**NINE MILE POINT
NUCLEAR STATION**

SUBJECT: Nine Mile Point Nuclear Station
Unit No. 2; Docket No. 50-410

License Amendment Request Pursuant to 10 CFR 50.90: Standby Liquid Control
System – Increase in Isotopic Enrichment of Boron-10

Figure 3.1.7-1 (Page 1 of 1)
Sodium Pentaborate Solution Volume/Concentration Requirements

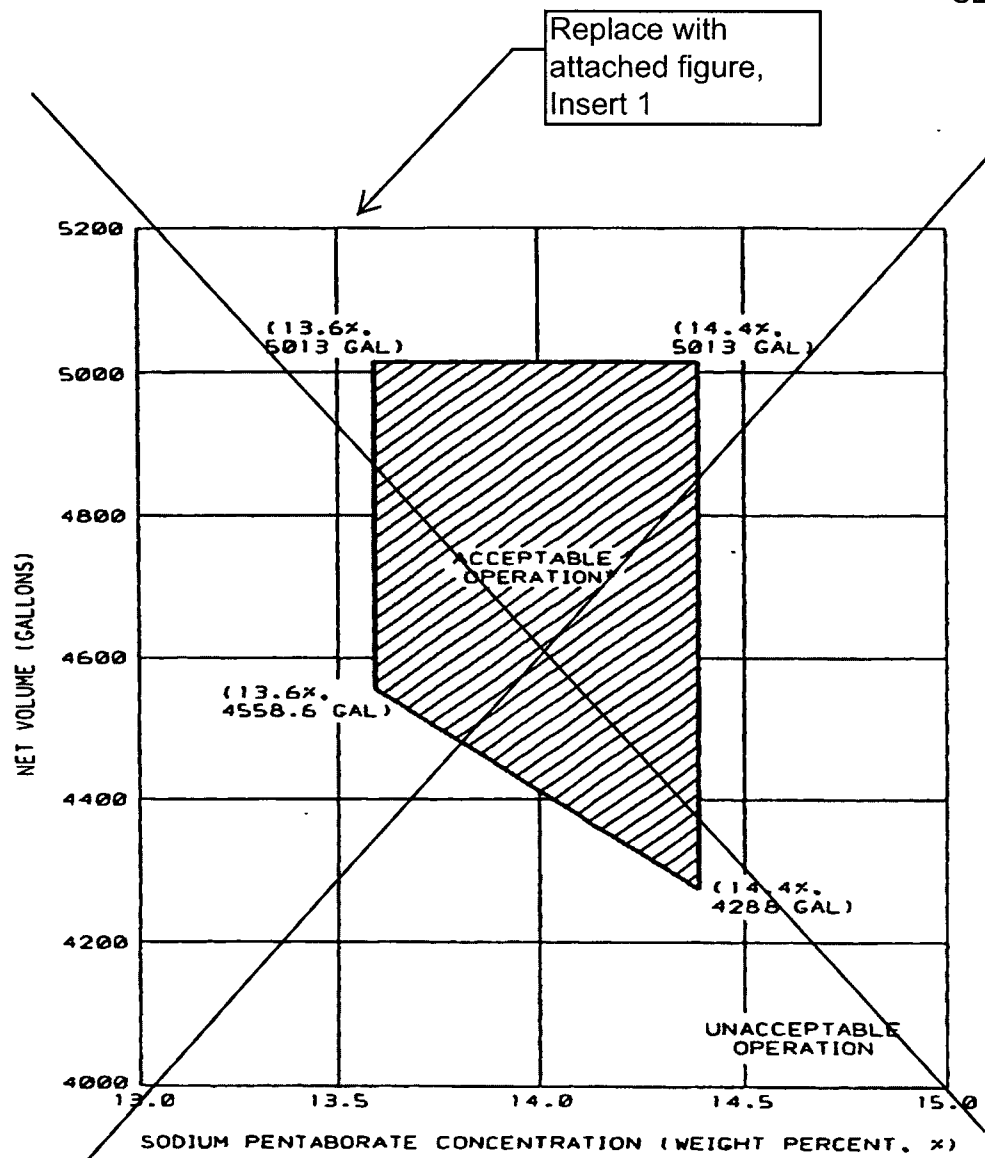
TS Figure 3.1.7-1, sodium pentaborate Solution Volume/Concentration Requirements, is revised to account for the change in the minimum volume in the SLC System tank that arises from the enrichment increase. At a sodium pentaborate concentration of 13.6% the minimum volume changes from 4,558.6 gallons to 1,600 gallons. At a sodium pentaborate concentration of 14.4%, the minimum volume changes from 4,288 gallons to 1,530 gallons.

The proposed boron-10 enrichment value allows the minimum solution volume stored in the SLC System storage tank to be decreased to 1,530 gallons at a sodium pentaborate concentration of 14.4% and 1,600 gallons at a sodium pentaborate concentration of 13.6%. The mark-up of NMP2 TS Figure 3.1.7-1 provided in Attachment 1 of this Enclosure delineates the proposed change in the minimum SLC System storage tank solution volume.

TS Insert 1 - Figure 3.1.7-1

92
